**CITY OF CHESTERFIELD
PLANNING AND PUBLIC WORKS COMMITTEE MEETING**

**THURSDAY, AUGUST 20, 2026
5:30 P.M.**

RE: **Hilltown Village Lot 2 (Good Clean Dog):** An Amended Site Development Section Plan, Landscape Plan, Lighting Plan, and Amended Architectural Elevations for part of a 2.56-acre tract of land located at the intersection of Hilltown Village Center and Olive Boulevard.

Volz, Inc., in partnership with Mademan Design, LLC, and on behalf of Good Clean Dog Chesterfield, LLC, submitted an Amended Site Development Section Plan, Landscape Plan, Lighting Plan, and Amended Architectural Elevations for the redevelopment of an existing structure on a portion of a 2.56-acre tract at the intersection of Hilltown Village Center and Olive Boulevard, in preparation for converting the site from a childcare facility to a dog grooming facility.

Figure 8: From top to bottom, South Elevation, West Elevation, North Elevation, East Elevation

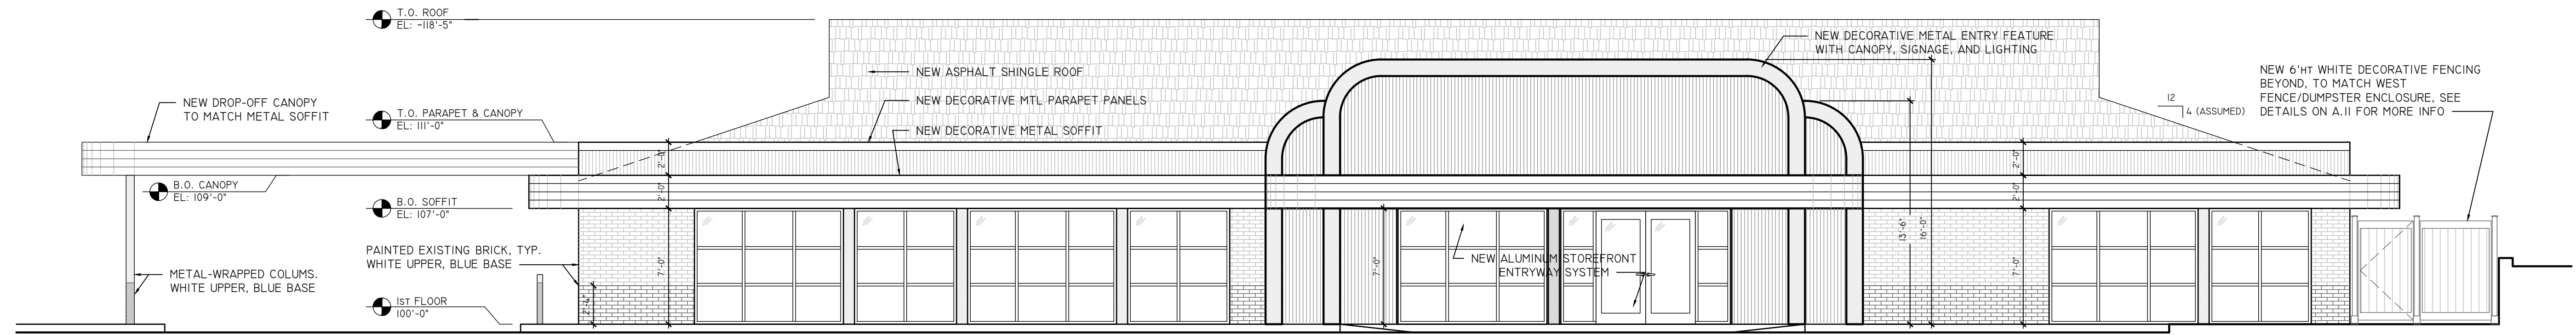
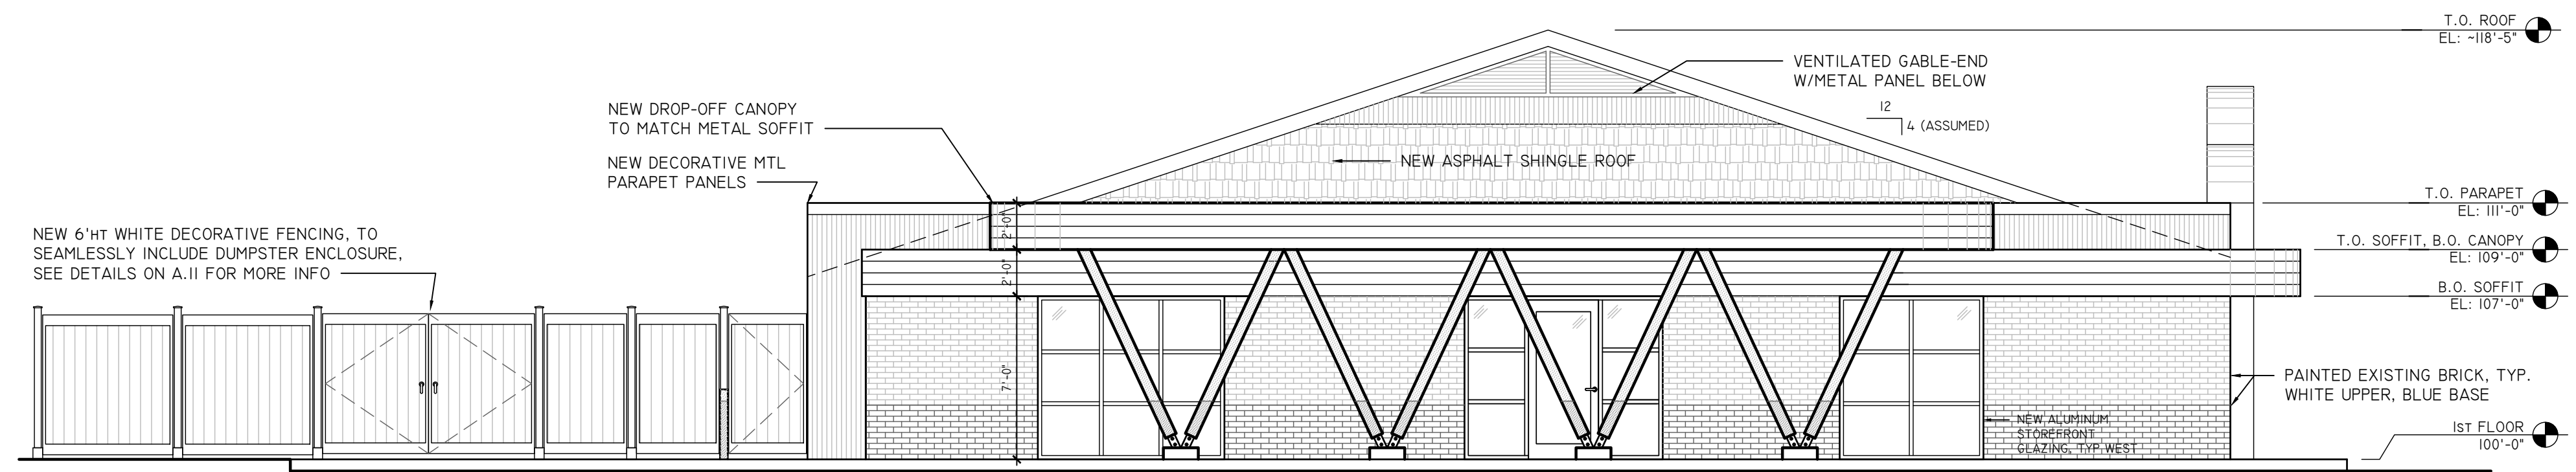
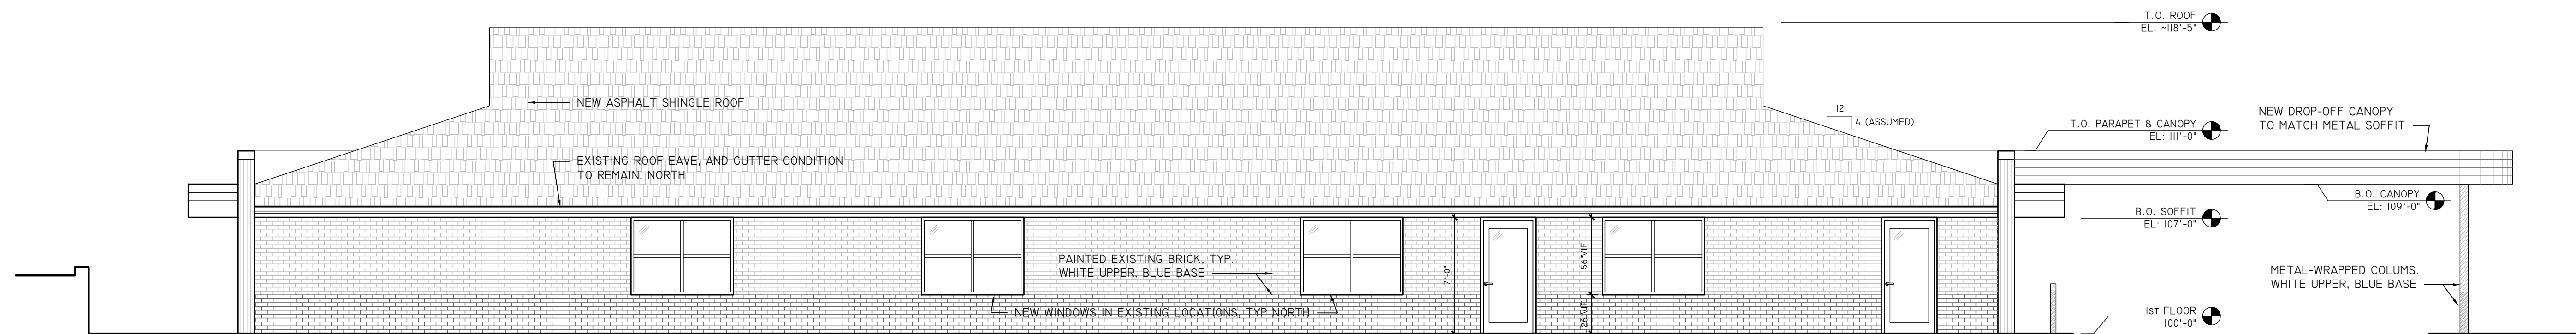
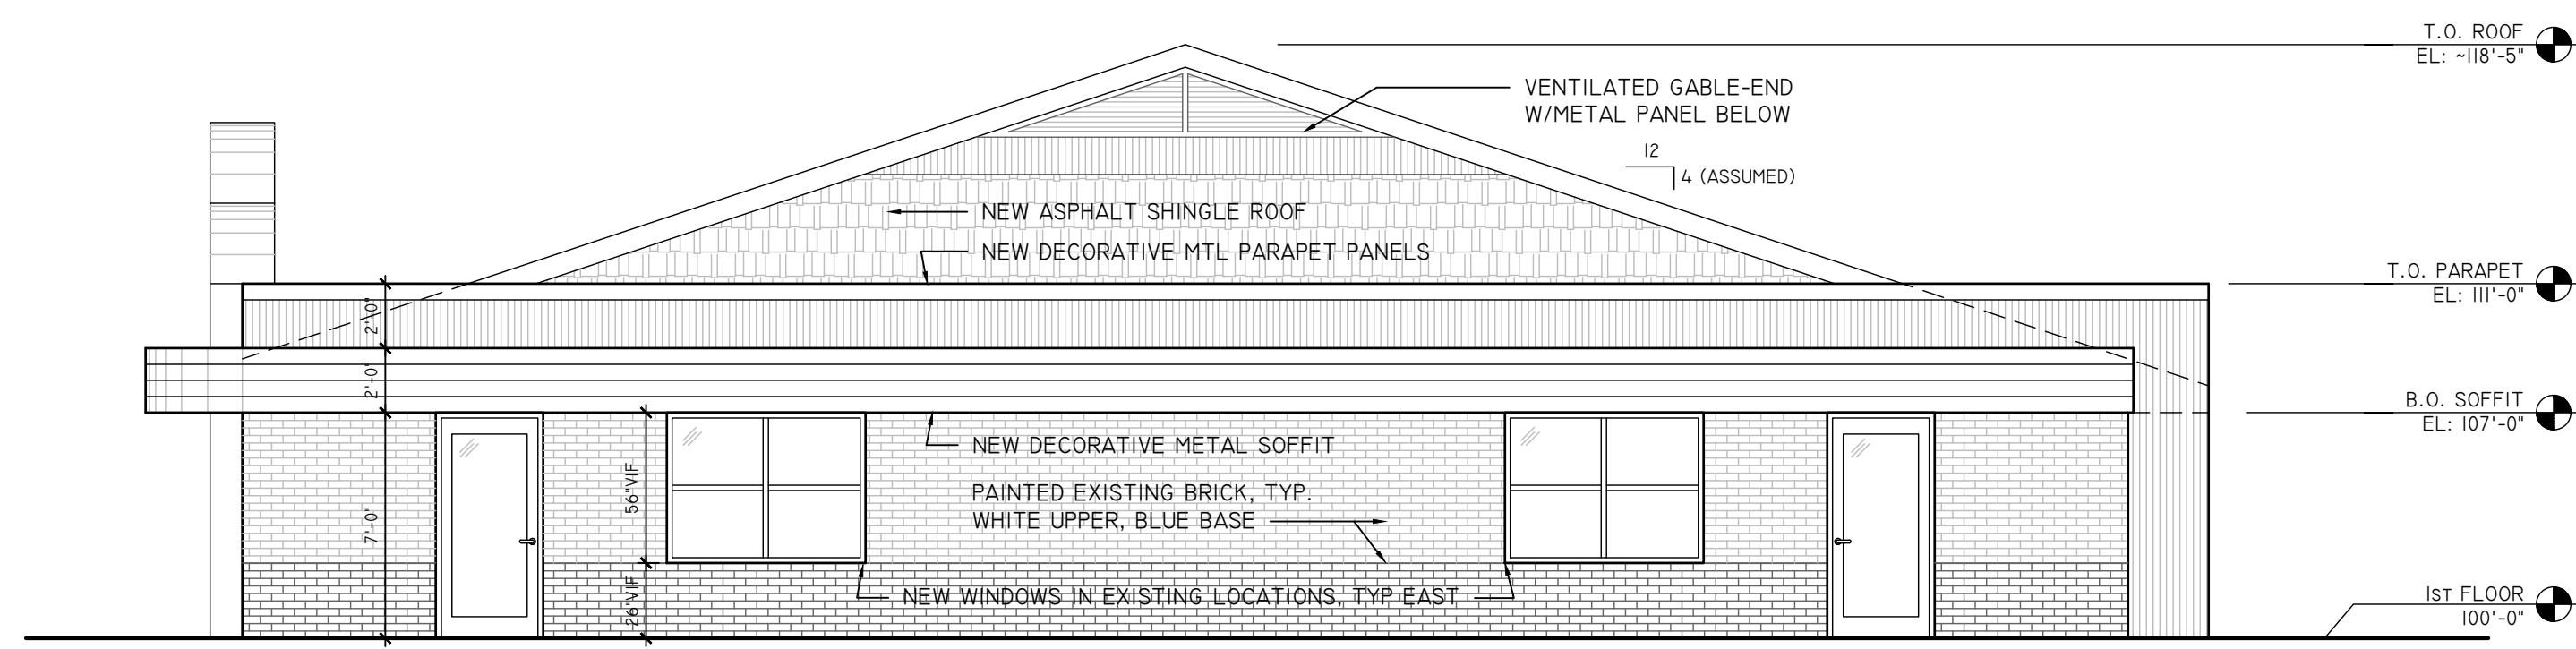
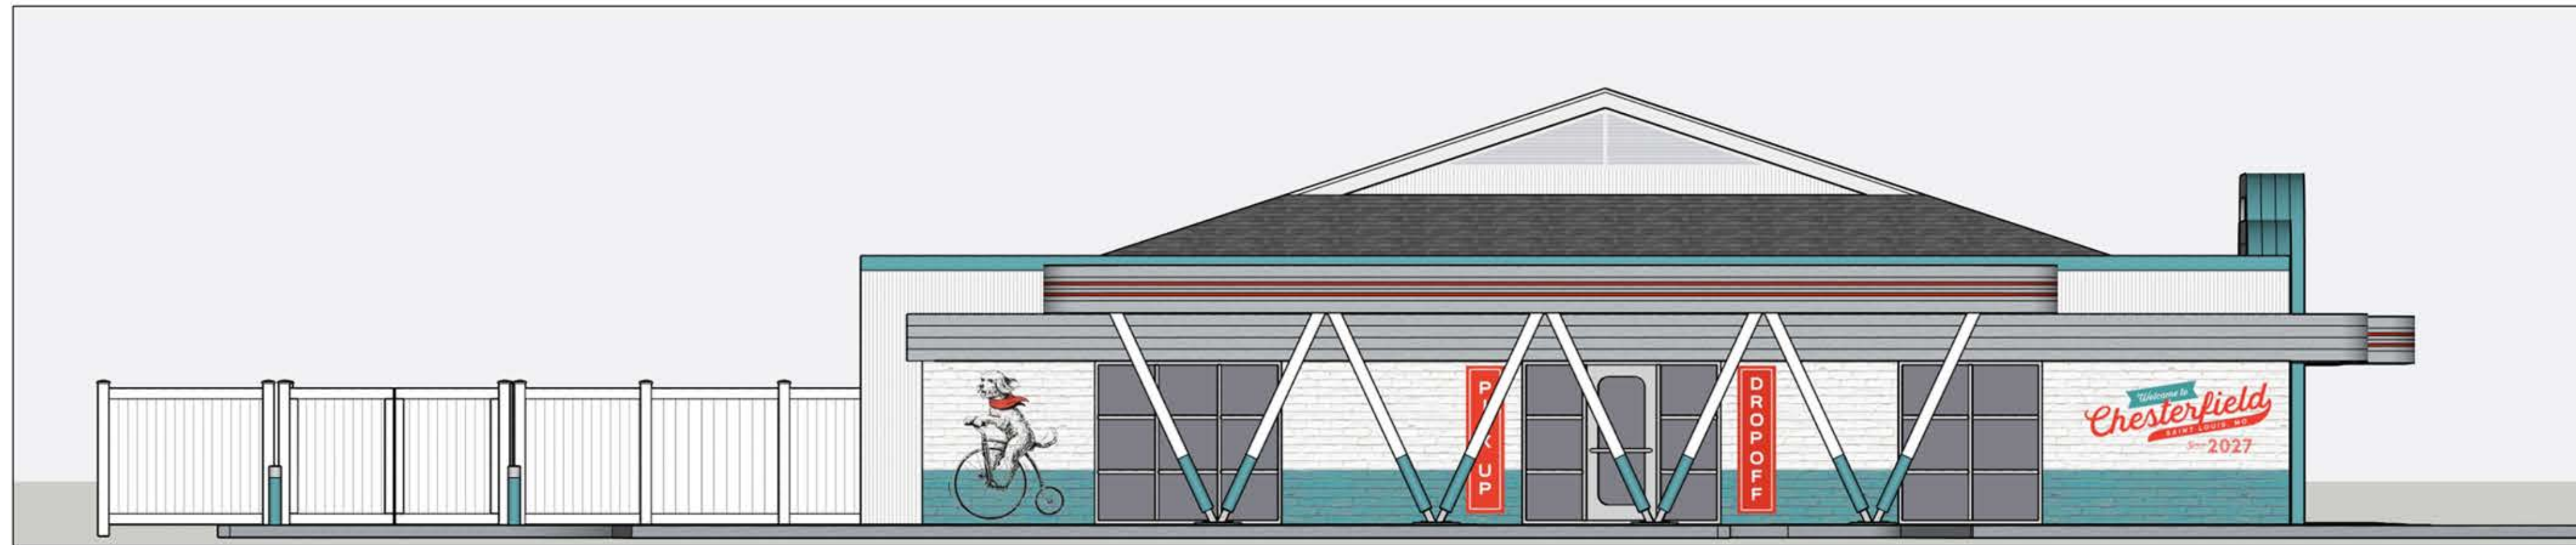
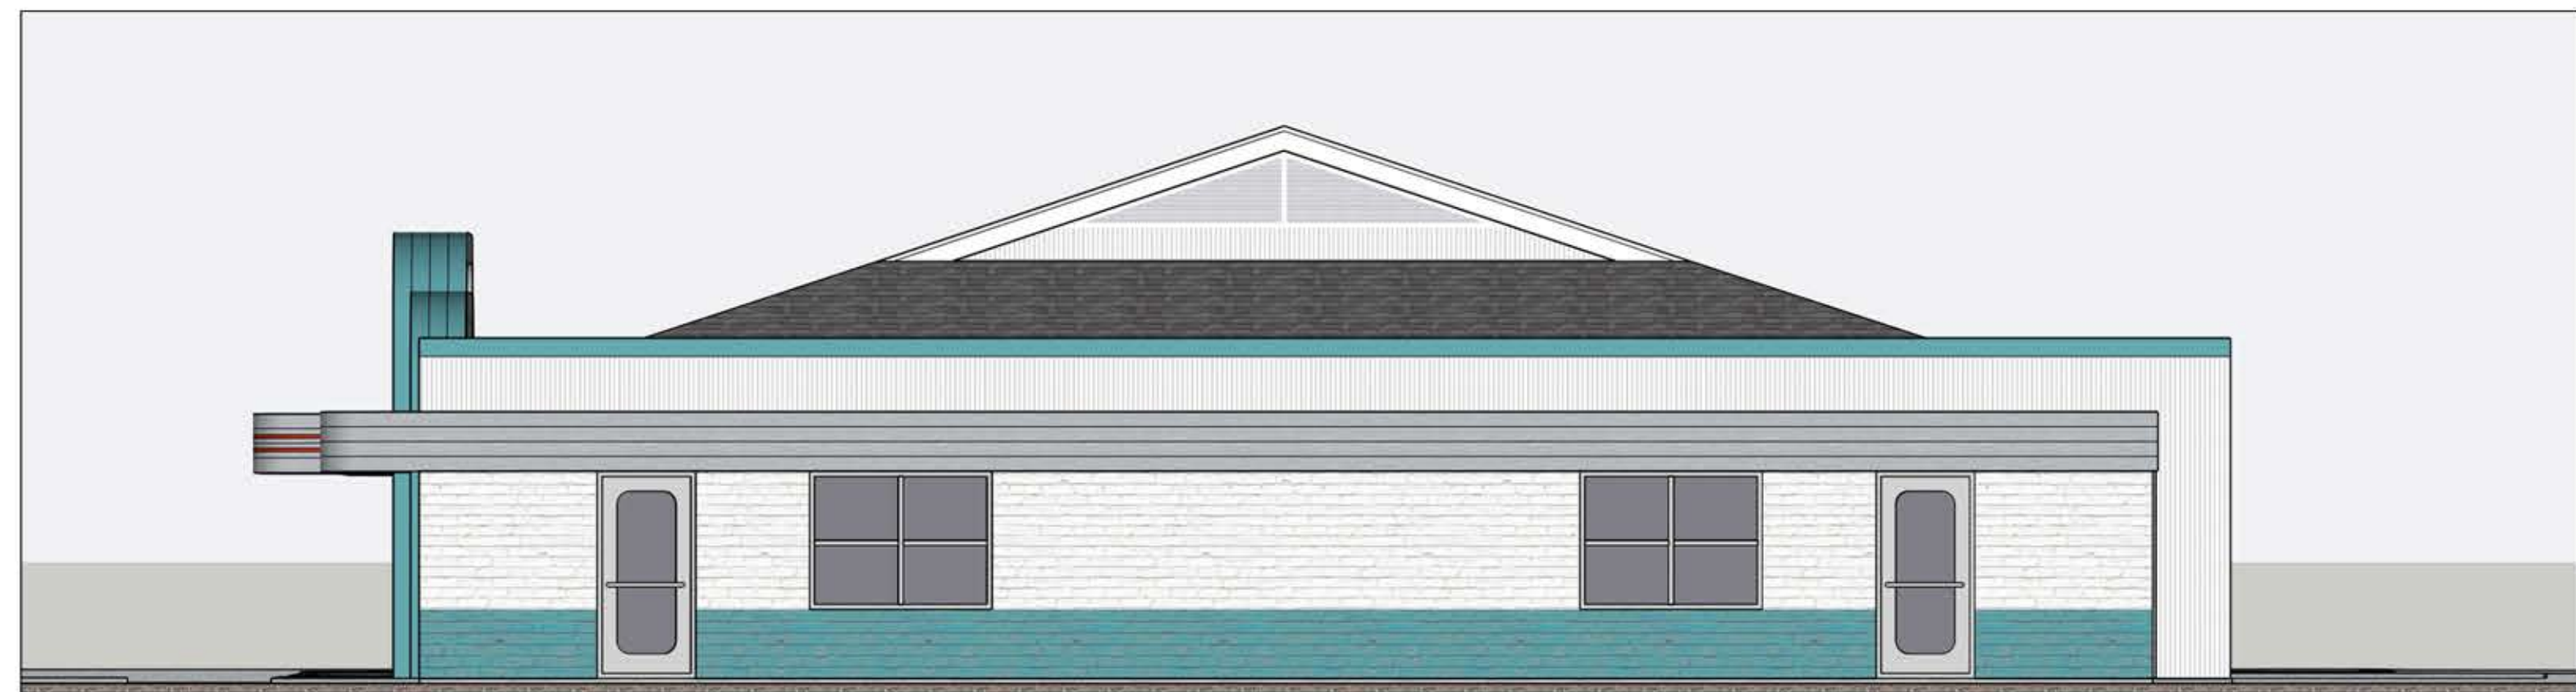
On July 9, 2026, the City of Chesterfield Architectural Review Board reviewed the Amended Site Development Section Plan and Architectural Review Board Submittal for Hilltown Village Lot 2 (Good Clean Dog) and issued the following conditions of approval:

1. Change the roof shingle material color to a grayer or cooler tone.
2. Provide City Hall with additional color and material samples not presented to the ARB (glass, colored metal coping, colored treated metal, etc.).

The applicant has since submitted revised architectural elevations depicting the change in roof shingle color to Estate Gray, and additional exterior material samples were dropped off for ARB review the week following the meeting. Upon review, the ARB had no objections to the proposed changes and additional samples.
